ADDENDUM NO. 1

DATE: July 1, 2020

MERCED COLLEGE HEALTH CENTER PROJECT
MCCD BID NO. 2020-03

DARDEN PROJECT NO. 1954
DSA File Nos. 24-C1
DSA APPL. NO. 02-118108

104 Office

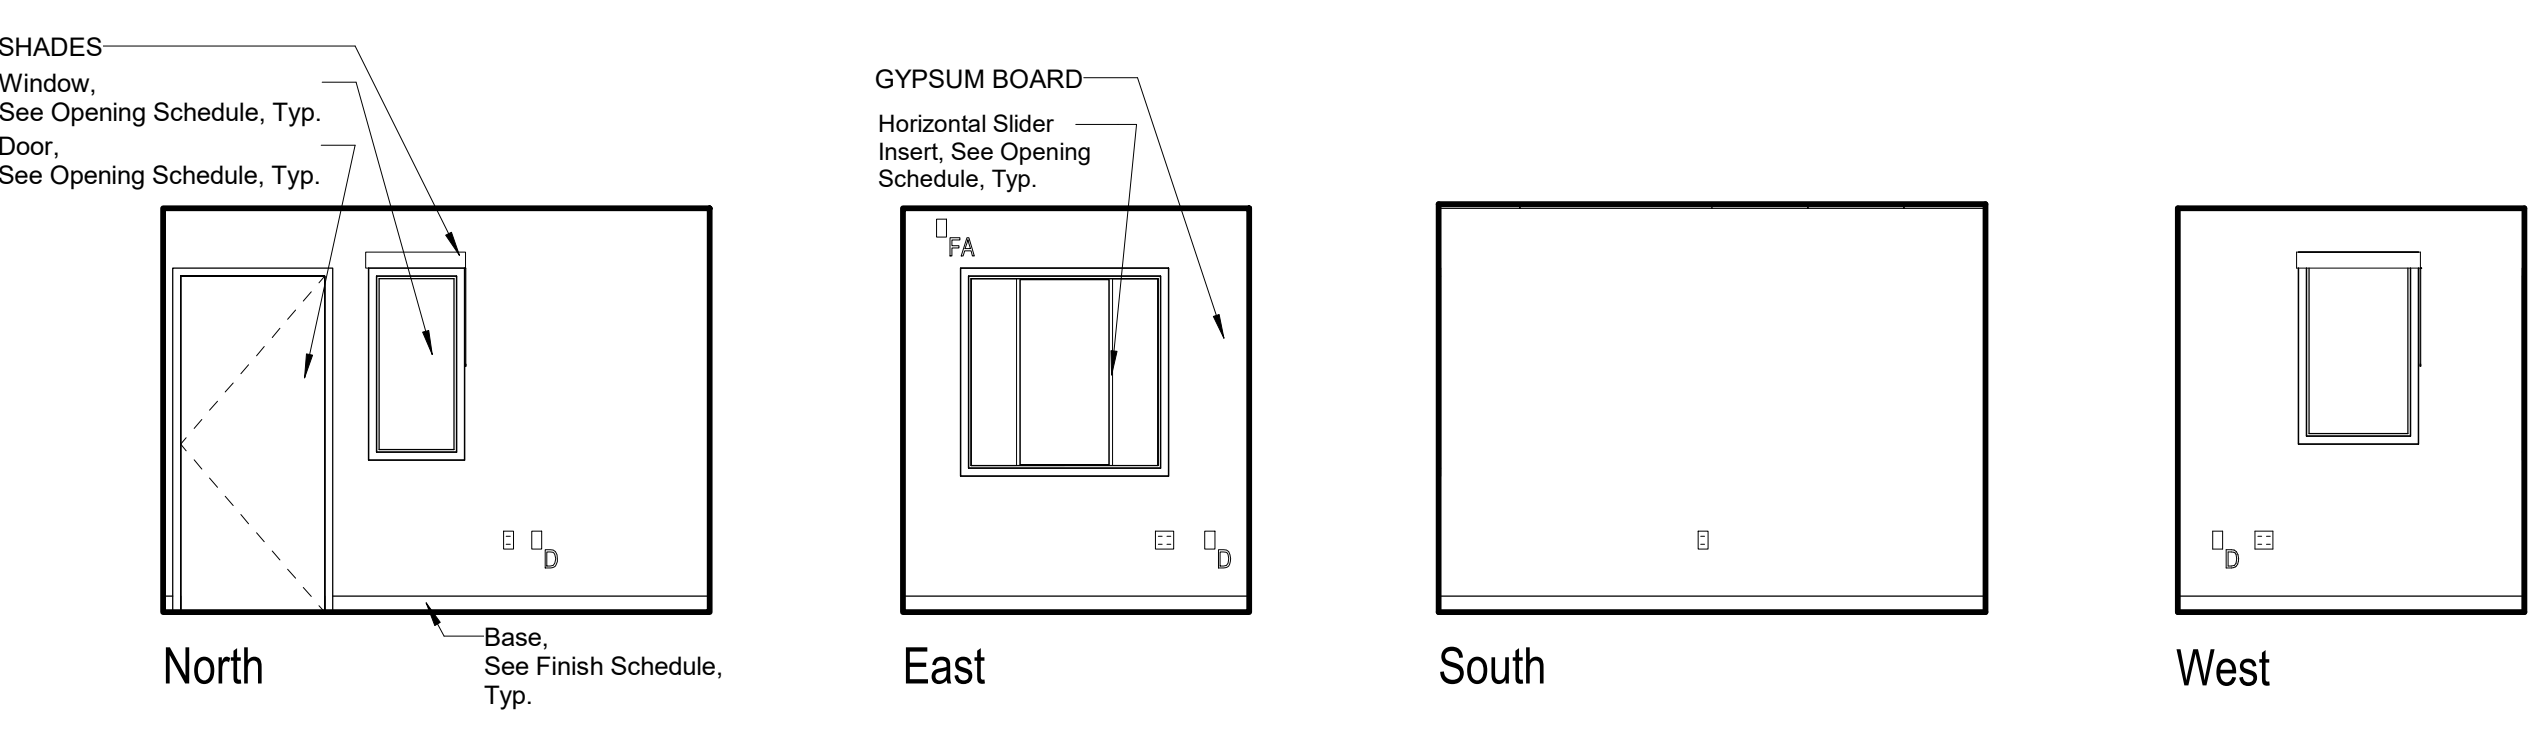
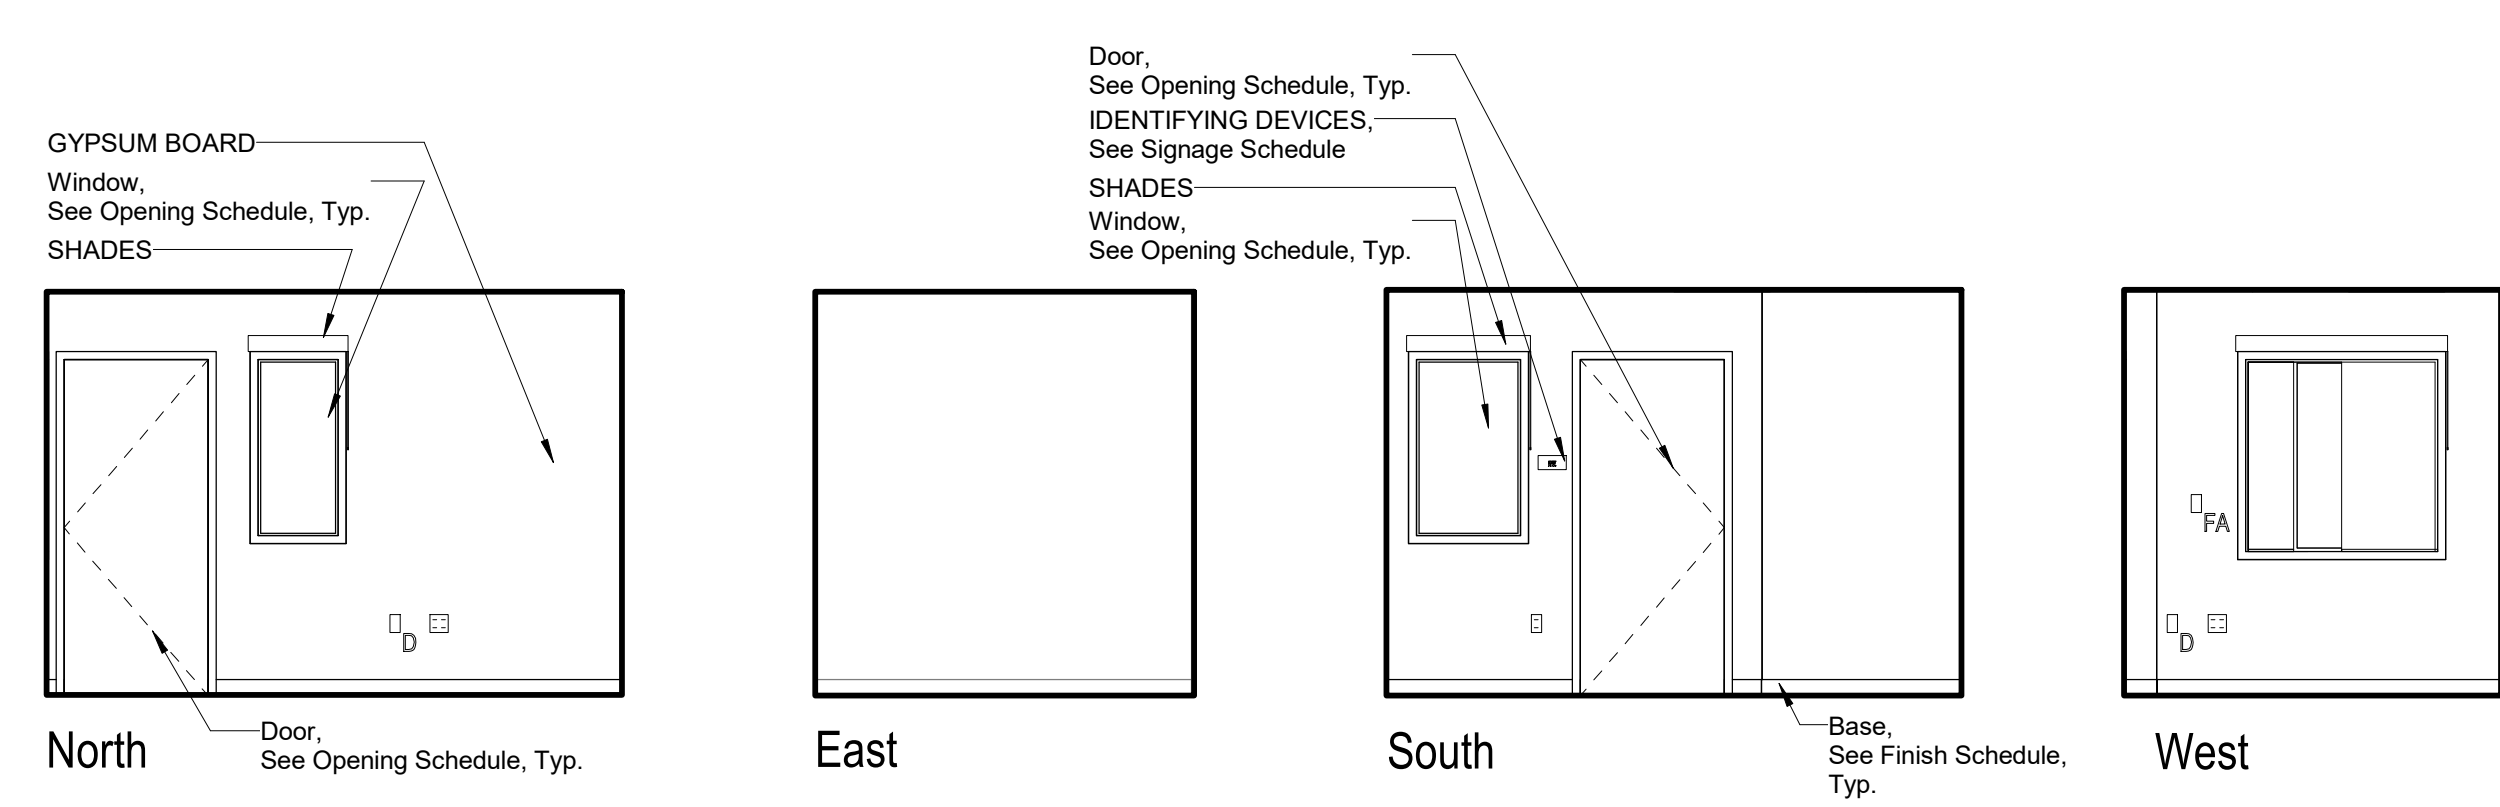
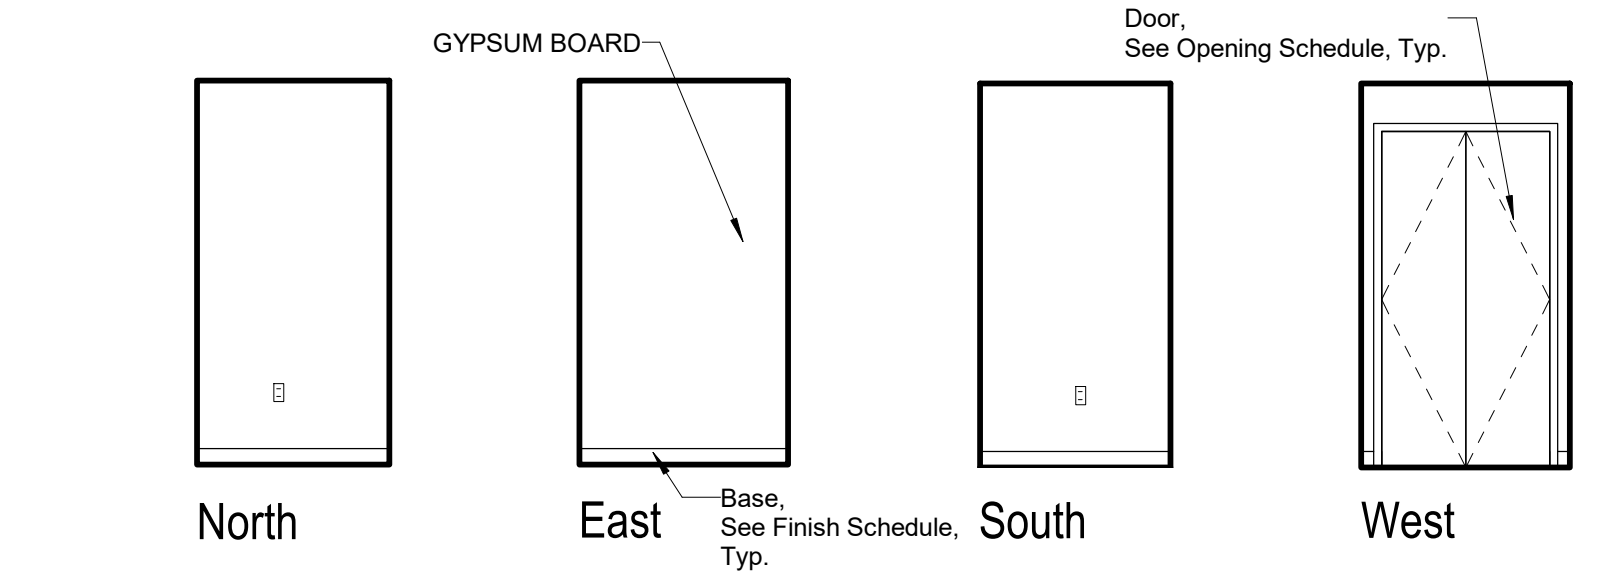
- AD1-A03 Refer to Sheet A/A601, INTERIOR ELEVATIONS:**
1. Remove and replace sheet A/A601, INTERIOR ELEVATIONS with the attached AD1-AX01.

AD1-AX02

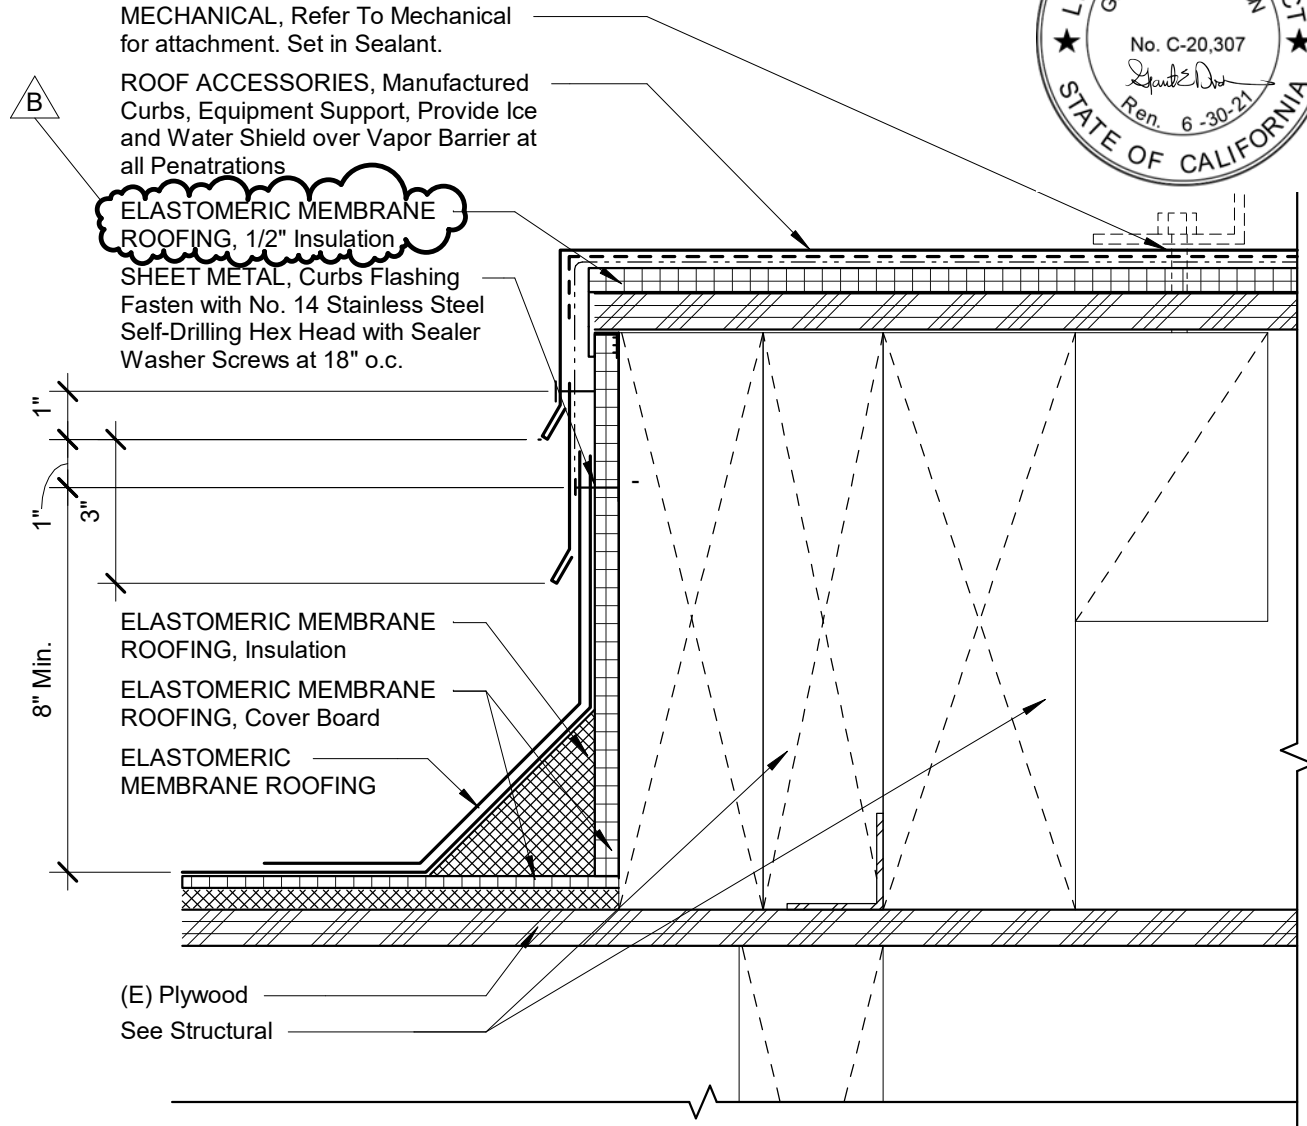
- AD1-A02 Refer to Sheet A/A301, DEMOLITION ROOF PLAN & ROOF PLAN:**
1. Refer to the drawing at N14.
 2. Remove and replace the "*ROOF ACCESORIES, Manufactured Curbs, Equipment Platform*" drawing with the attached AD1-AX02.
